Commission on Community Investment and Infrastructure

Variation to Rooftop Mechanical Screening Development Control for Transbay Block 2W

Transbay Redevelopment Project Area

July 21, 2026

East Clementina Street Elevation (from future Transbay Block 3, Park) showing rooftop mechanical equipment.

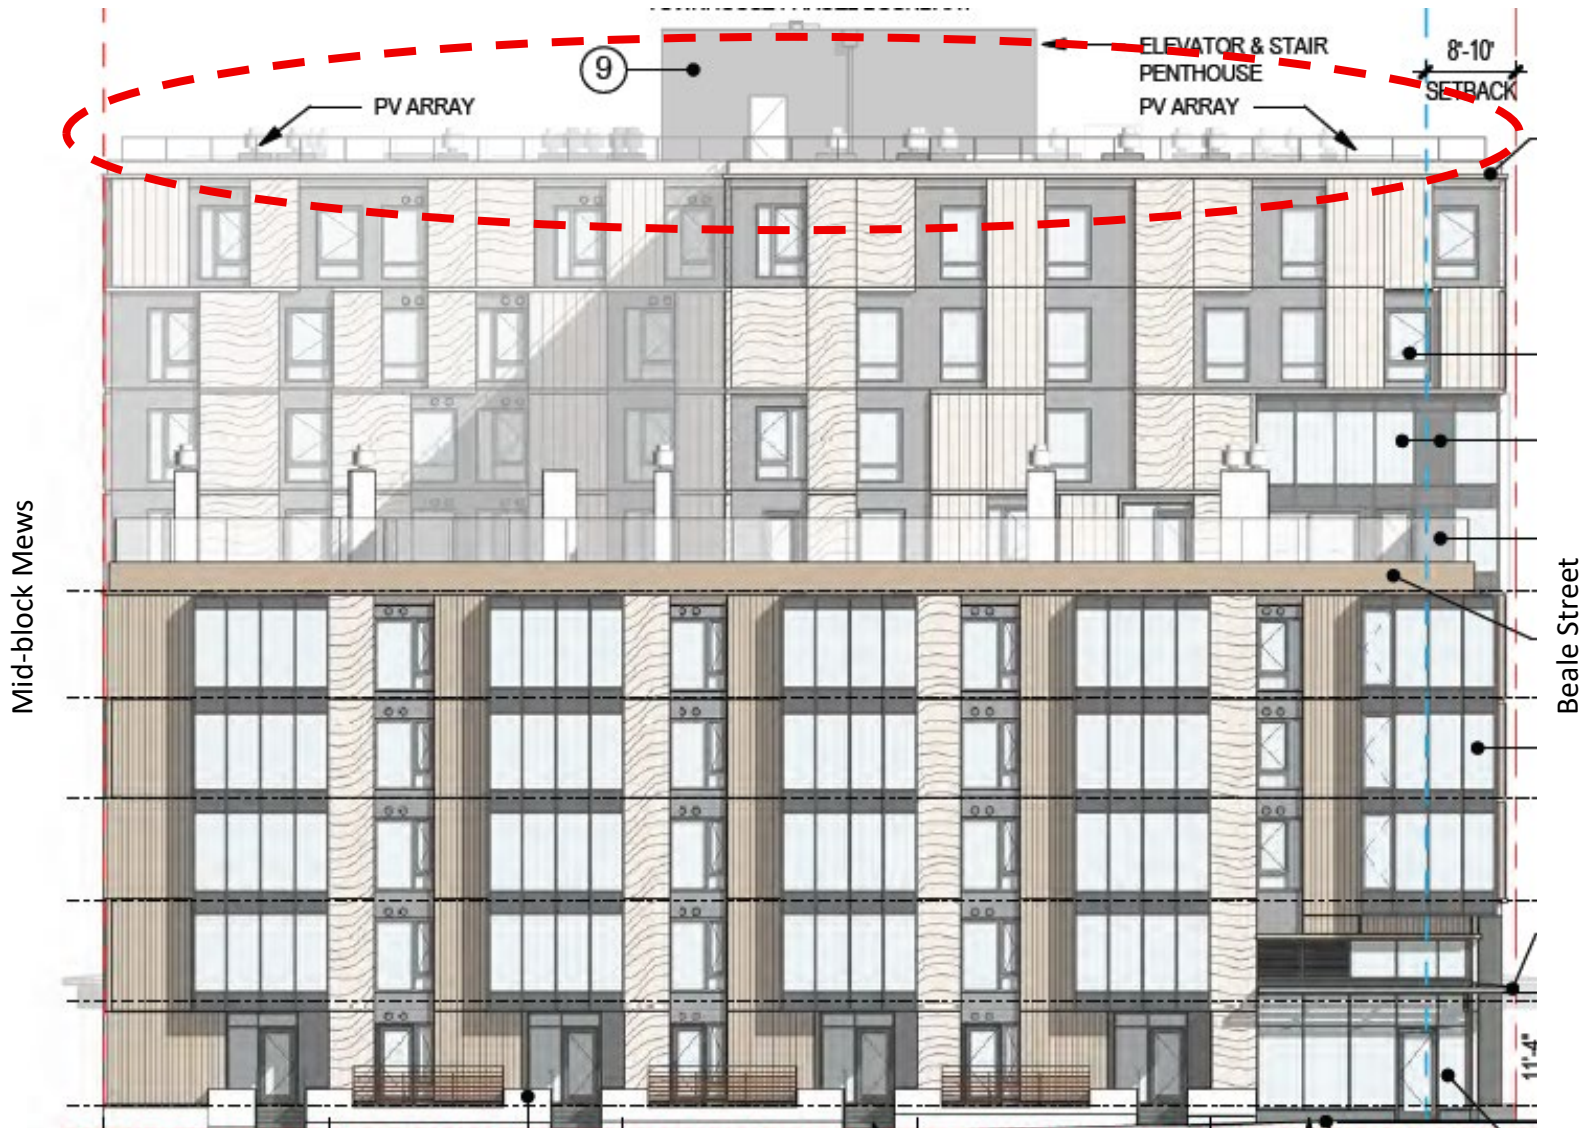
Approving a Variation for the Transbay Block 2 West project of the Rooftop Mechanical Screening Development Control required by the Transbay Development Controls and Design Guidelines; Transbay Redevelopment Project Area

View from Beale Street with two visible equipment

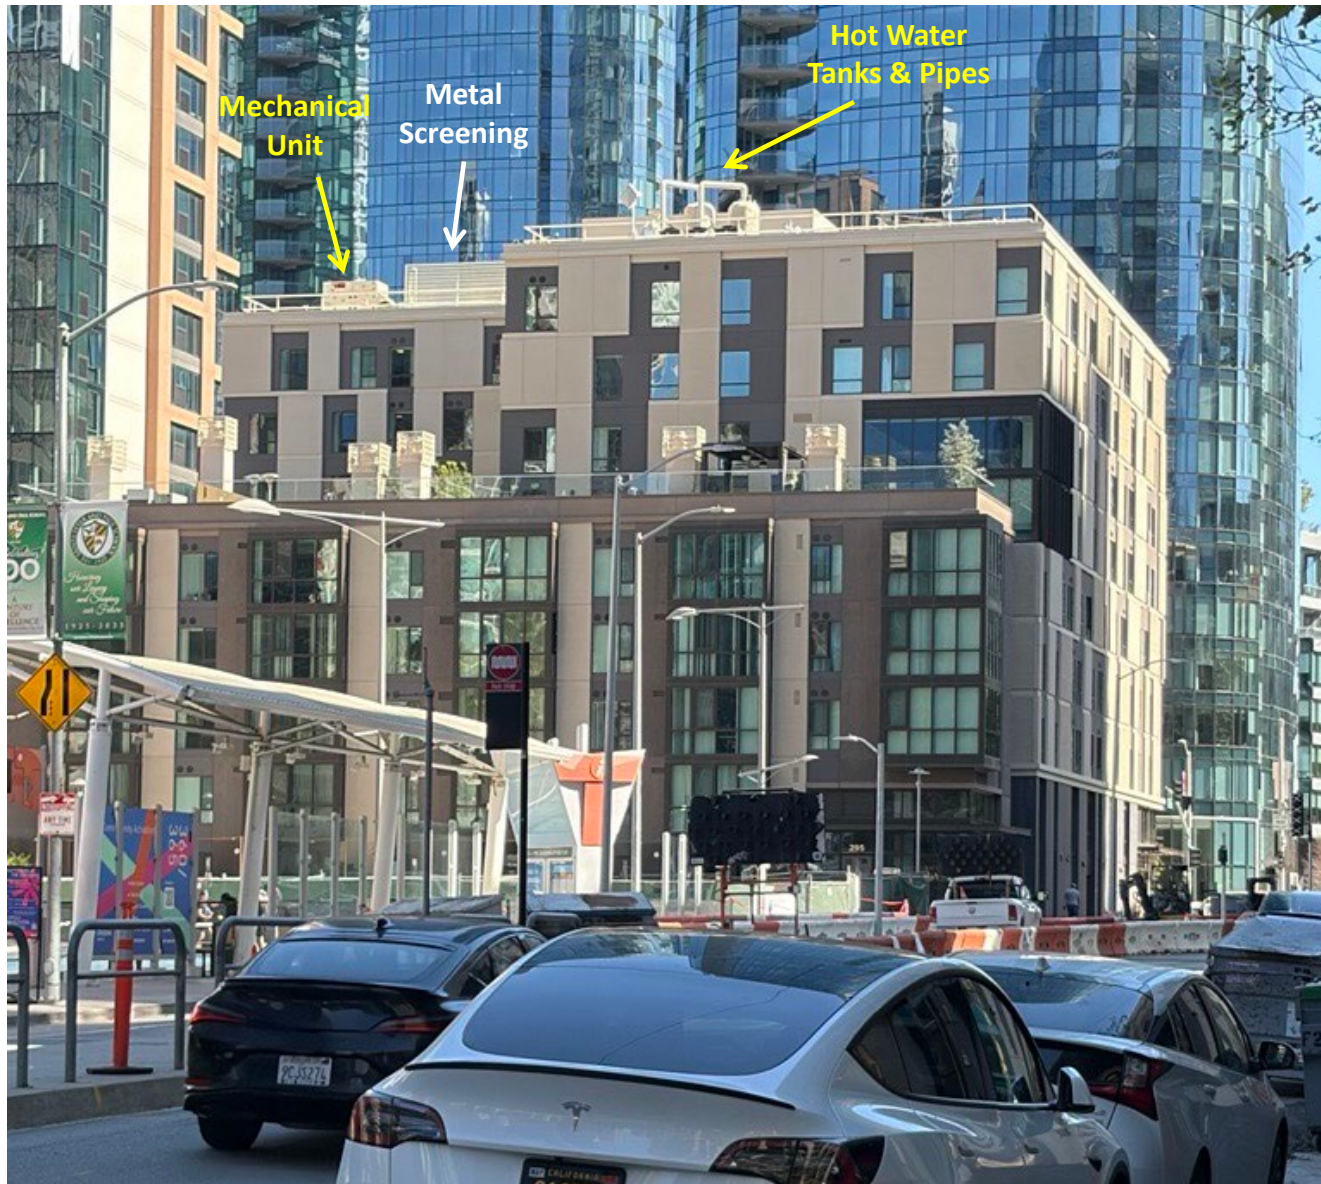
b. Further develop any rooftop mechanical equipment screening. Rooftop mechanical equipment, with the exception of solar PV infrastructure, shall be screened from view from the public realm. Mechanical screens shall form part of the building top composition and consist of materials consistent with the overall building color and material palette.

- **Practical Difficulty/Undue Hardship:**
Enforcing requirement will necessitate substantial redesign, construction rework, delay and multiple subcontractor re-mobilizations.
- **Unique Physical Constraints/Extraordinary Circumstances:**
Roof area demonstrates regulatory clearance constraints for building maintenance, pathways and green roof coverages.
- **No Material Detriment to Public Welfare or Neighboring Properties or Improvements in the Vicinity:**
Water tanks and pipes are set further back from the railing to draw minimal attention. Focus remains on the design of the low-rise massing facing the public realm. Regular box-shape of mechanical unit does not detract from overall façade. Both equipment are shielded from adjacent Lumina Development.
